This Addendum forms a part of the contract documents. It modifies them as follows:

DISCIPLINES: Architecture, Mechanical, Electrical, Plumbing

**NUTTER HALL
RENOVATIONS**
FAIRFIELD, MAINE

SK-1

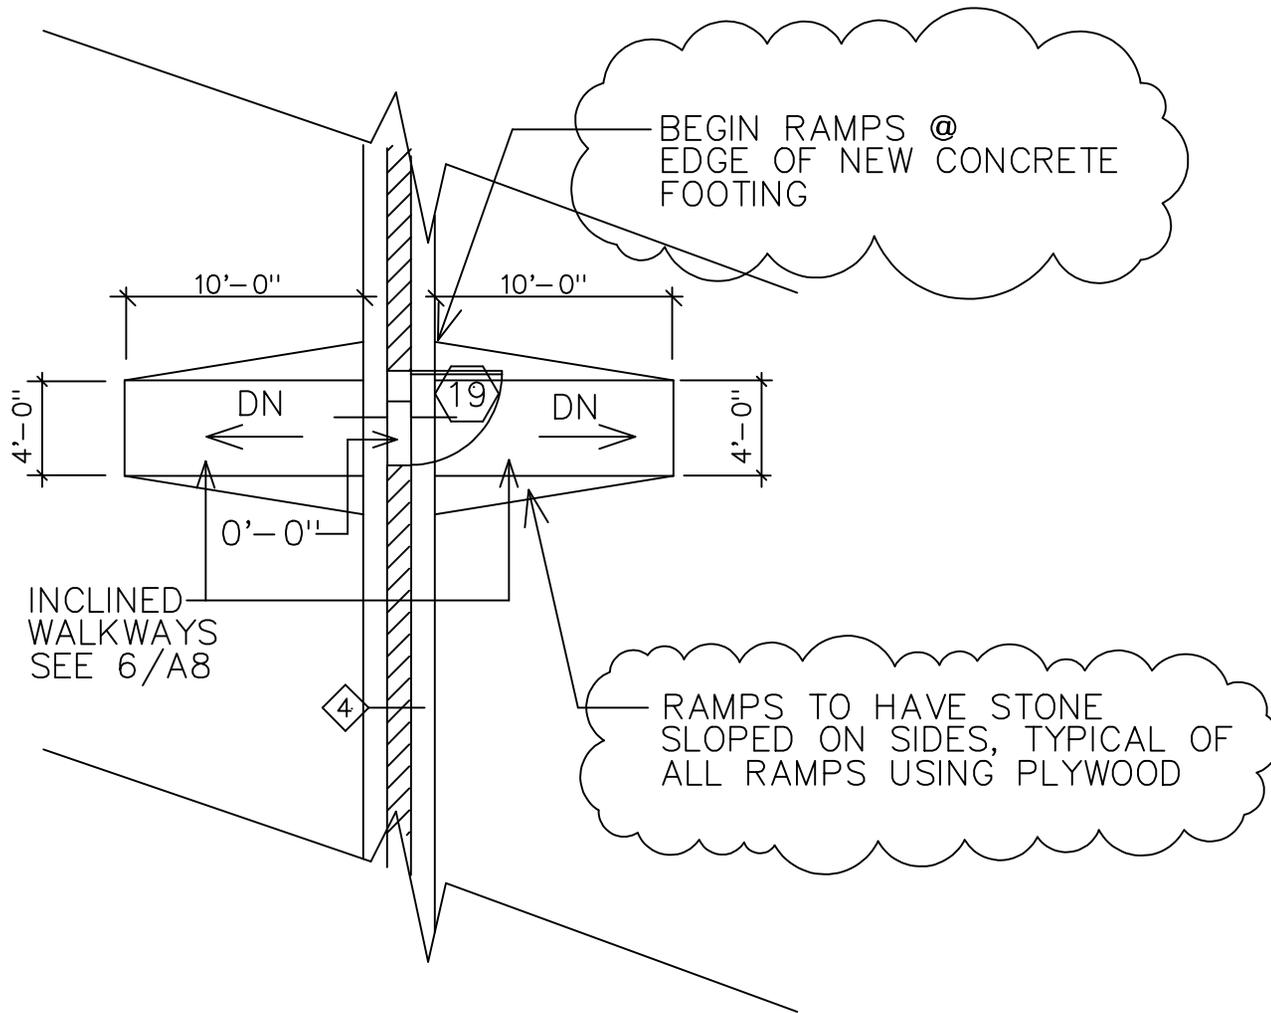
- A1 MODIFY the legend according to SK-1.
- A1 MODIFY the ramps to Door 19 according to SK-2.
- A2 MODIFY the east end of View A according to SK-3.
- A2 MODIFY the west end of View B according to SK-4.

SK-5

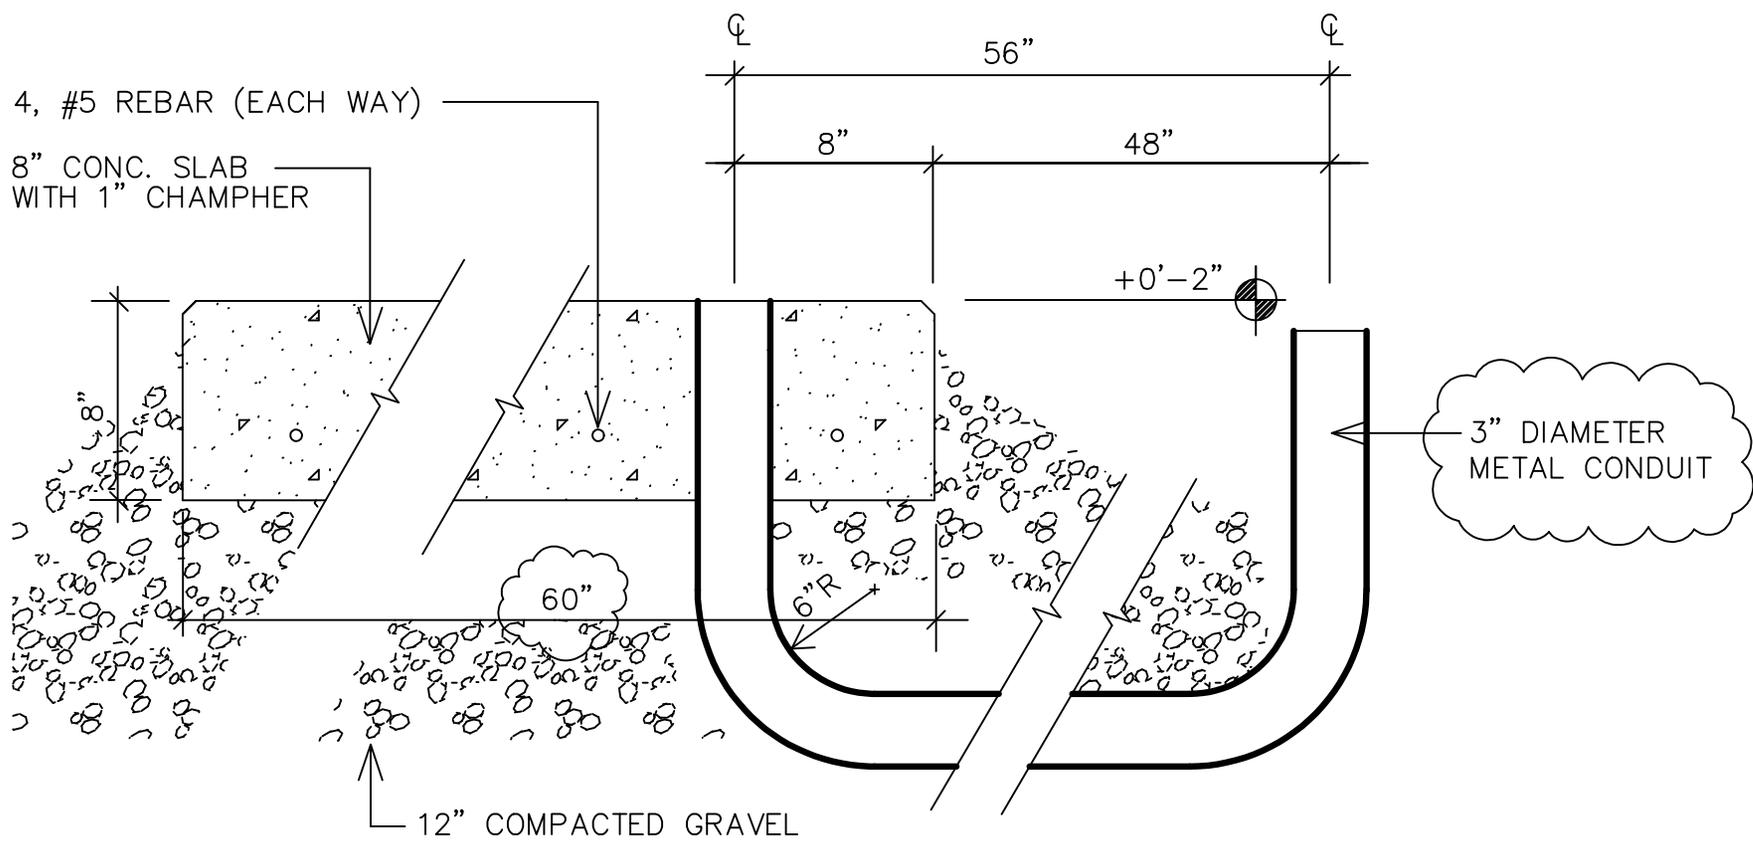
- A2 ADD the dimensions according to SK-5 to View E.
- A3 CHANGE the "16-18""dimension of the toilet from the wall in 2/A3 to "18"".
- A4 CHANGE Note # 2 under the door schedule written as "ABI #2" to "ABI # 4".

LEWIS + MALM ARCHITECTURE 124 MAIN STREET, BUCKSPORT, MAINE 04496 PHONE: (207) 469-7440 FAX: (207) 469-2181
NUTTER HALL RENOVATIONS FAIRFIELD, MAINE
TRANSFORMER DETAIL
JOB# 1438 DATE: 23JUL2015
REF: A9 SK-6

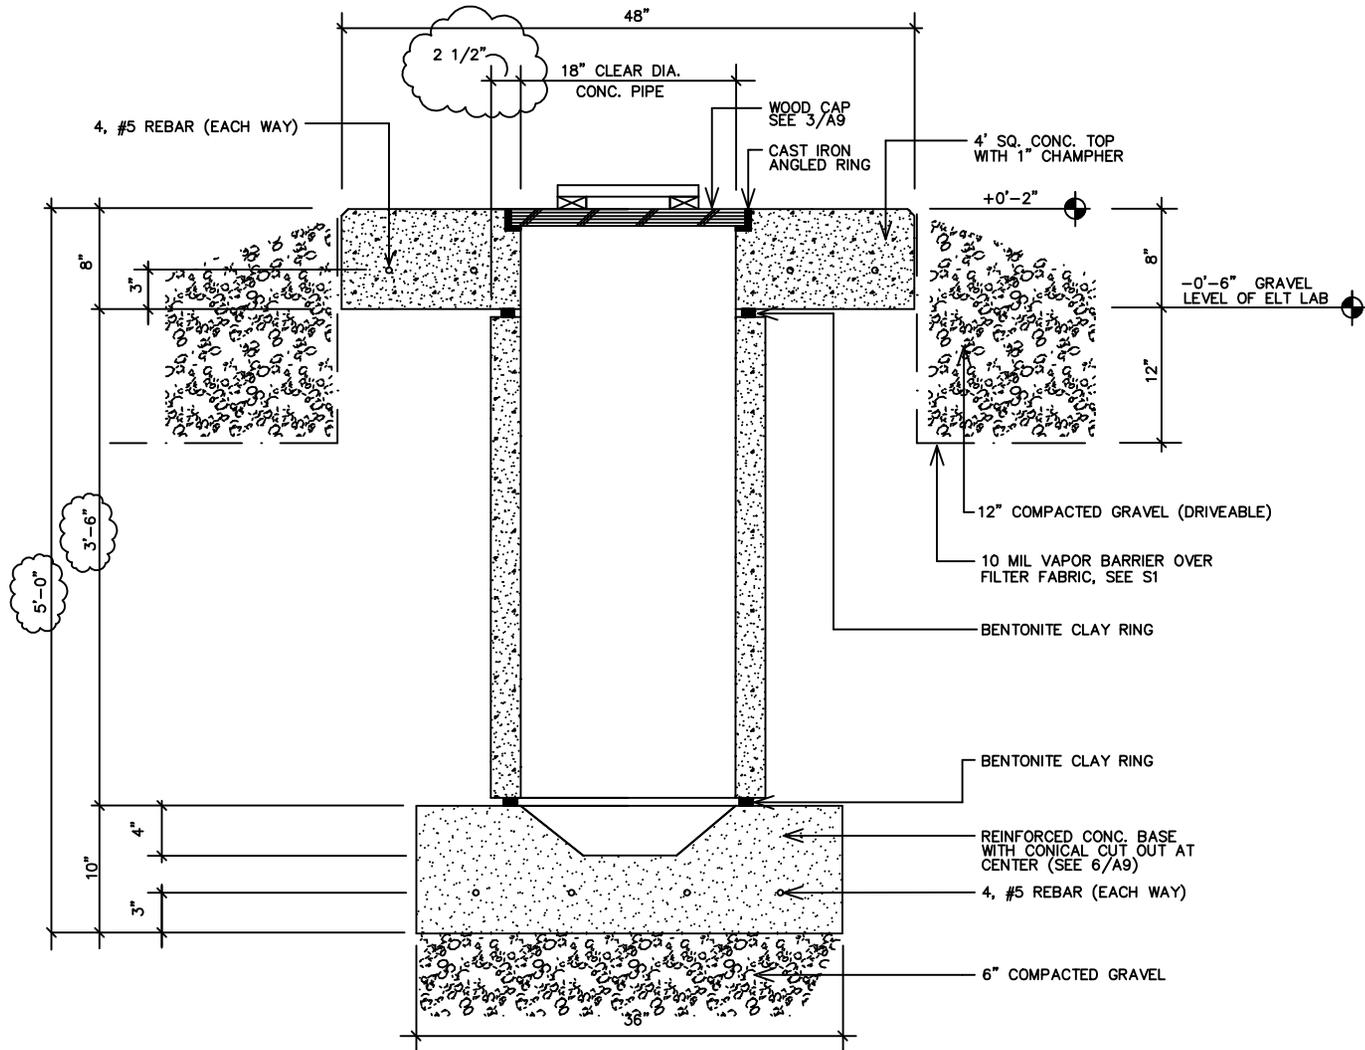
A9 MODIFY the design of the transformer pad shown in detail 4/A9 according to SK-6.

SK-7

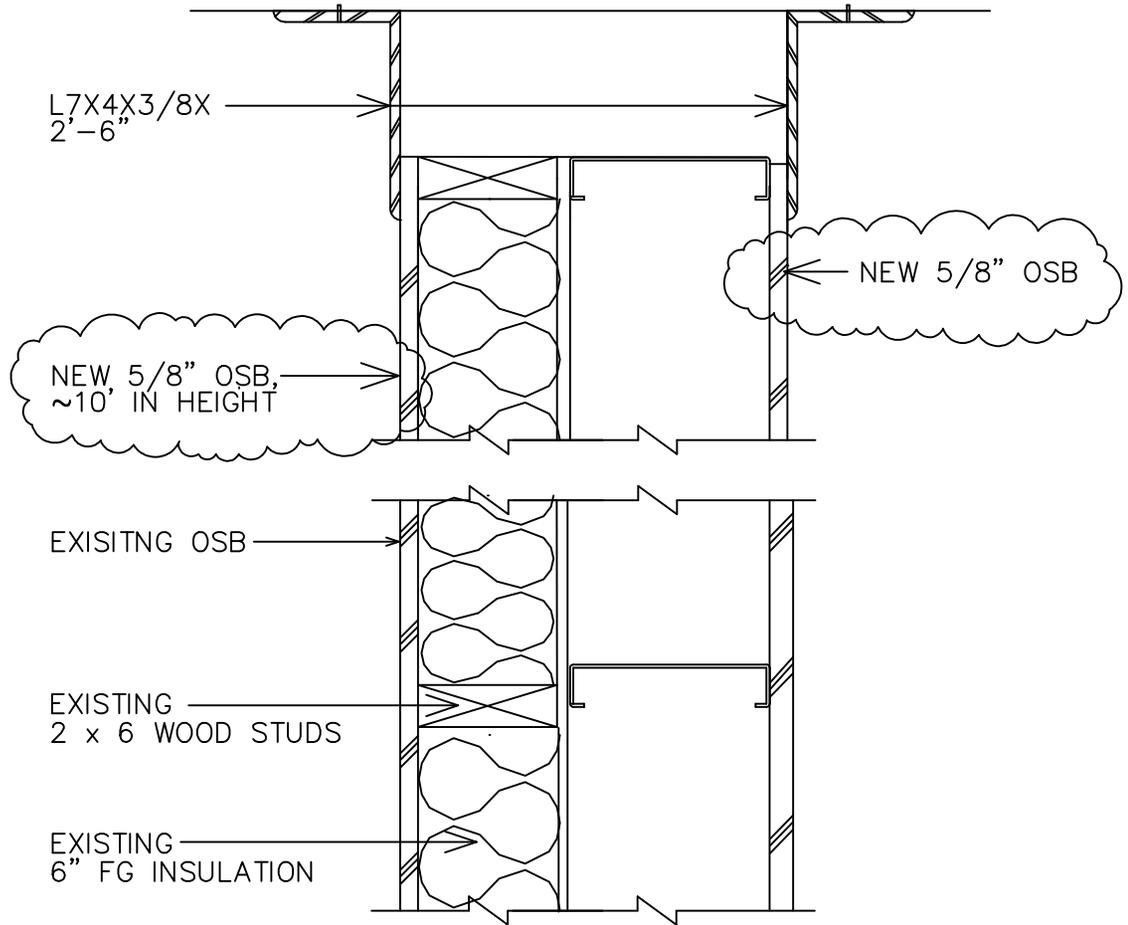
- A1 ADD note that window "A" installation in Corridor 114 is part of ADD ALTERNATE #7.
- A1 In the ELT Lab 104 CHANGE the note "(12) UTILITY POLE BASES" to "**(10)** UTILITY POLE BASES"
